## **Technical Bulletin**

Date of issue: 29th June 2015

## Samil Power solution for AS5033 amendment 2, 11th of July 2015

Fig1: Typical Samilportal topology and operational characteristics

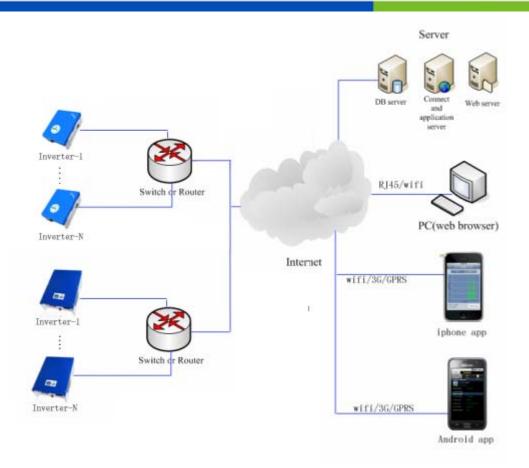
- a) The installation must be in accordance with the prescribed product user manuals and guidelines. A Wifi or hard wired Ethernet connection must be made and established as per Samilportal topology Fig1.
- b) The Earth Fault Alarm must be enabled as per Samilportal installation example in Fig2.
- c) Make sure that account of Samilportal is an available email which is used for receiving alarm report. The acquiescent time interval is 1 hour.
